SUBJECT: Focused Evaluation of External Flooding
Grand Gulf Nuclear Station – Unit 1
Docket Nos. 50-416
License Nos. NPF-29

2017 Focused Evaluation for External Flooding at Grand Gulf Nuclear Station

Appendix 1 – LIP FLO-2D Model Concerns

Figure 1.1: FLO-2D Grid Cell Elevation for Door OCT5 (No. 25481)

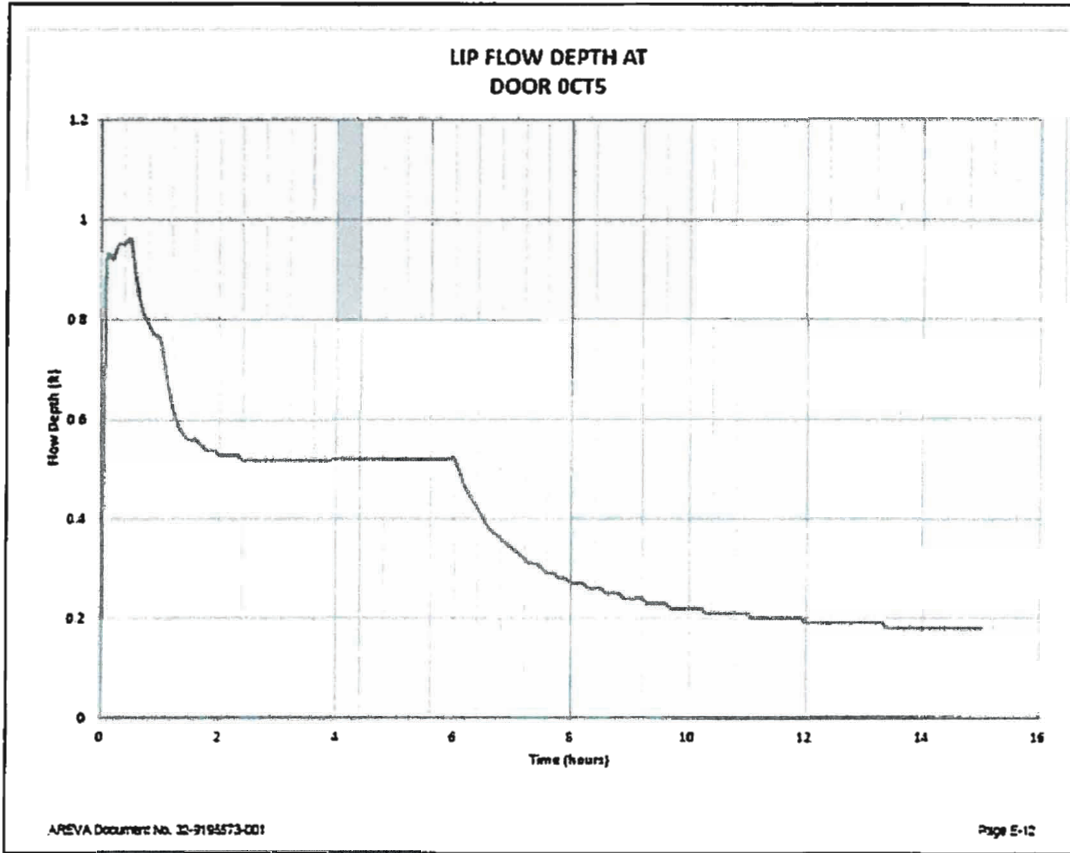
“The NRC staff also identified additional modeling issues related to the LIP FLO-2D simulations, such as inaccurate water budgets and unrealistic stage hydrographs (e.g., FHRR Figures 3.1-9, 3.1-10, 3.1-14, and 3.1-16), which show high flood stages even after the ending of the postulated PMP event. Also, the NRC staff was unable to verify the accuracy of water budgets and long-tails on the simulated stage hydrographs presented in FHRR Figures 3.1-9, 3.1-10, 3.1-14, and 3.1-16.”

- 1) Door OCT5 (Grid Cell 25481 with elevation 132.67 ft-site datum). Figure 1.1 represents the stage-duration relationship for this door. It shows approximately 0.2 ft flow depth at the end of the simulation (15 hours). The assessment shows that this grid cell and other close by cells are relatively flat, and have relatively lower elevations compared to the outer surrounding cells as shown in Figure 1.1. Therefore, ponding for longer duration with a relatively constant flow depth is expected, which justifies the longer recession limbs and shallow depth shown in the stage-duration hydrograph in Figure 1.2.
